Nant Mithil Energy Park, Powys.
PEDW DNS Application Ref: DNS CAS-01907-D7Q6Z1.

CPRW-RE-think Chapter 18 on

Secondary Consents

Evidence by CPRW-RE-think on:
Secondary Consents

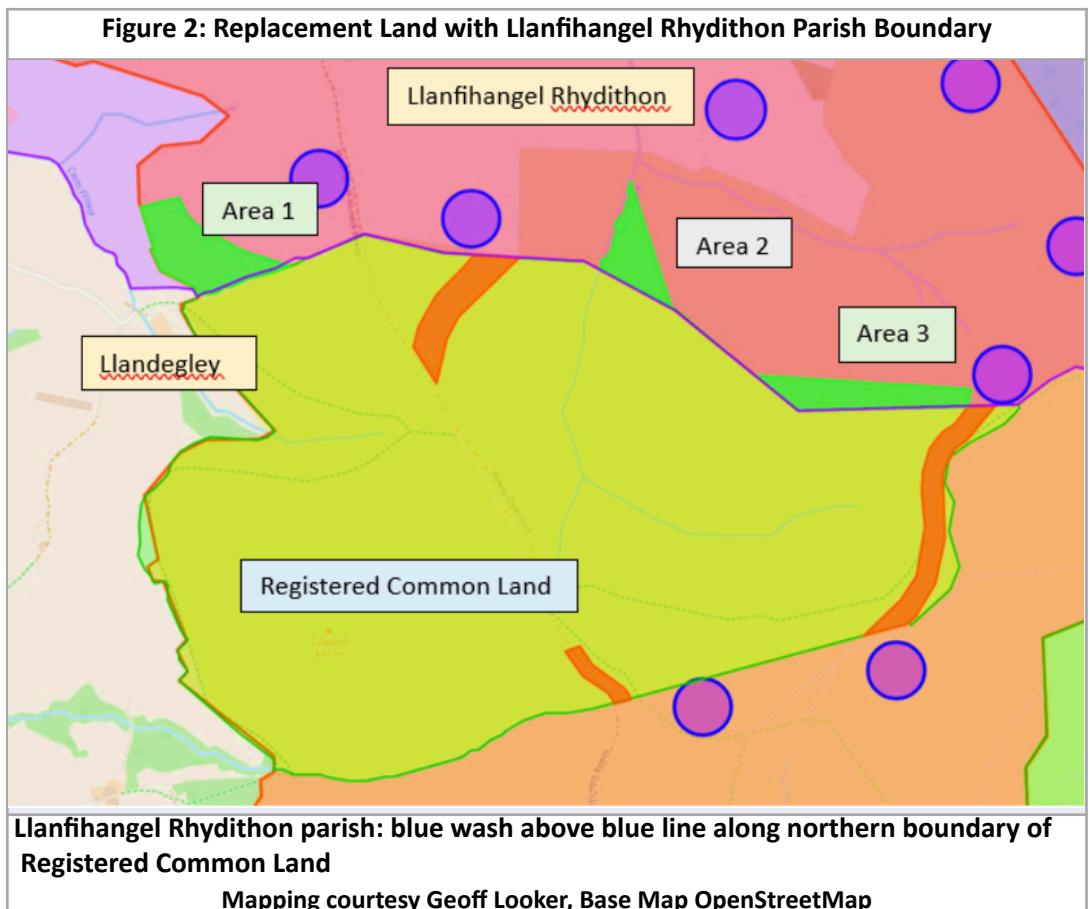
- 3.3. Areas 2 and 3 of the replacement land are on Open Country land which has statutory access rights on foot. See fig SC.1. Indeed, at Section C1, Q22b, the applicant states: *“The public currently have access to Replacement Land Areas 2 and 3 under the Countryside and Rights of Way Act 2000”*. The proposal to offer land contrary to the guidance was queried at PAC, when CPRW asked *“How do these two parcels comply with the expectation in Note 8 above?”*

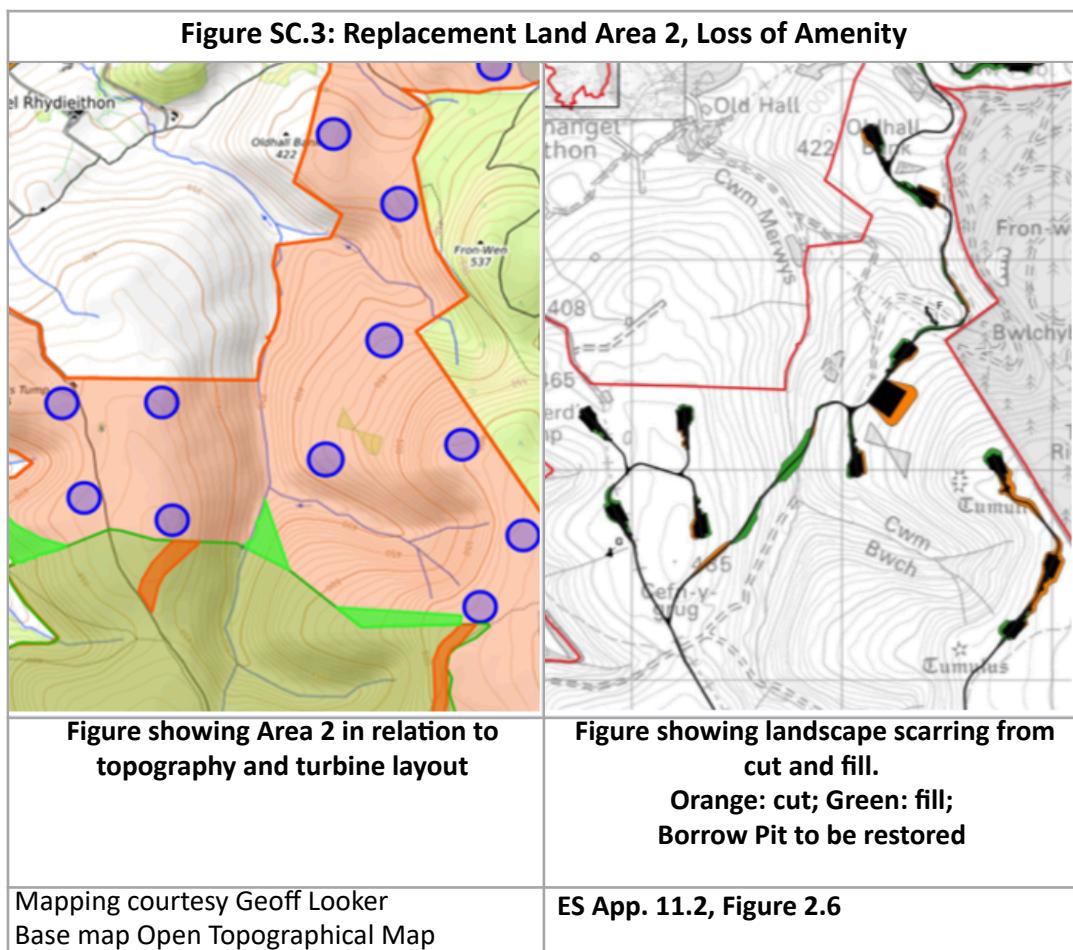
- 9.4. For the reality of Area 2 amenity post construction see Figure 3 below: One would be surrounded by turbines on three sides, each tower base the width of a small living room and each blade longer than a jumbo jet. If one stood halfway down Area 2 looking East, at about 1km away and on ground over 200m higher, 205m high T18, T19 and T20 would dominate. Looking north the *"views over the valley"* would be marred by a new access track and watercourse crossing engineered into both sides of a steep valley, all framed by towering wind turbines and a further engineered access track to the East T25 would be overbearing because of proximity and disconcerting because of its elevation relative to the other wind turbines. The proposed riverine enhancement planting will not mitigate any of this, (app. 7.10, Drawing 1). We seriously doubt anybody would choose to *"stop on their travels over the adjacent common, enter the land to take in the views over the valley"*.
